5-1 – 12

502.1, 502.9 (New), 502.10 (New)

Proponent: Kim Paarlberg, International Code Council

Fig. 504.2
Treads and Risers for Accessible Stairways

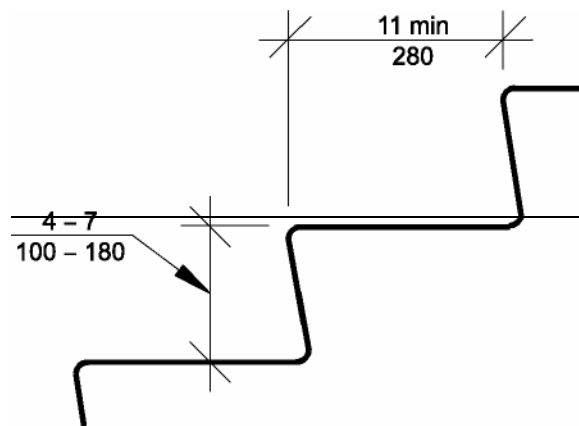
Delete without substitution as follows:

~~504.2 Treads and Risers.~~ All steps on a flight of stairs shall have uniform riser height and uniform tread depth. Risers shall be 4 inches (100 mm) minimum and 7 inches (180 mm) maximum in height. Treads shall be 11 inches (280 mm) minimum in depth.

Reason: These requirements are in International Building Code Section 1009. Stairs are not considered an accessible route of travel under the 2009 International Building Code, Chapter 11 or ICC/ANSI A117.1, Chapter 4.

Fig. 504.5
Stair Nosings

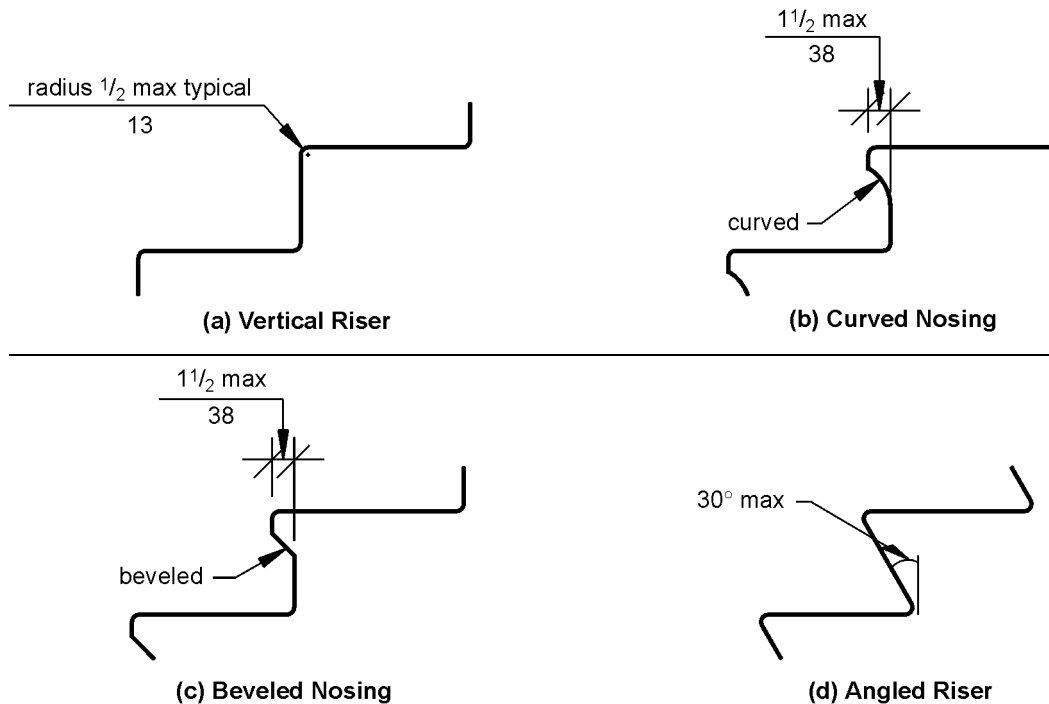
~~504.5 Nosings.~~ The radius of curvature at the leading edge of the tread shall be $\frac{1}{2}$ inch (13 mm) maximum. Nosings that project beyond risers shall have the underside of the leading edge curved or beveled. Risers shall be permitted to slope under the tread at an angle of 30 degrees maximum from vertical. The permitted projection of the nosing shall be $1\frac{1}{2}$ inches (38 mm) maximum over the tread or floor below.

~~504.5.1 Visual contrast.~~ The leading 2 inches (51 mm) of the tread shall have visual contrast of dark-on-light or light-on-dark from the remainder of the tread.

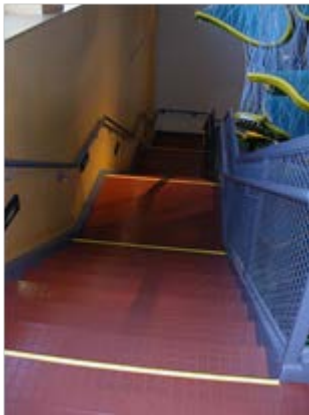
504.5.1 Visual contrast. At the nosing of a stairway landing and at the nosing of the bottom tread, the leading 2 inches (51 mm) of the landing or tread shall have visual contrast of dark on-light or light-on-dark from the remainder of the tread.

Cadence is established within two or three steps, so you do not look down at your feet. The location where the change is from level to steps and from steps to level is where the visual cues are relevant.

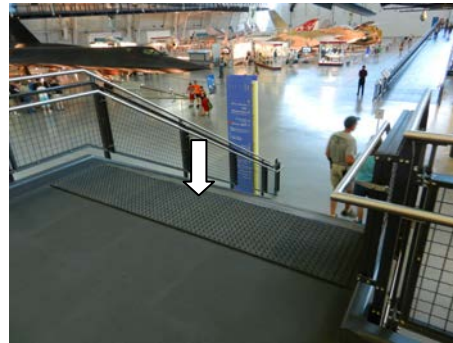
504.5.1 Visual contrast. The leading 2 inches (51 mm) of the landing or tread shall have visual contrast of dark on-light or light-on-dark from the remainder of the tread.

EXCEPTION: Where a stair has detectable warnings complying with Section 705 at the leading edge of each landing, visual contrast is not needed provided the detectable warnings extend the full width of the stairway and extend 24 inches minimum from the nosing.

Cadence is established within two or three steps, so you do not look down at your feet. The application shown is in the Air and Space Museum in Washington D.C. This may be a good option for high traffic stairways where the contrasting stripe might be worn off, or if the stairway is patterned so that there contrasting color is in question, or in stairways where there is a requirement for photoluminescent striping also required.
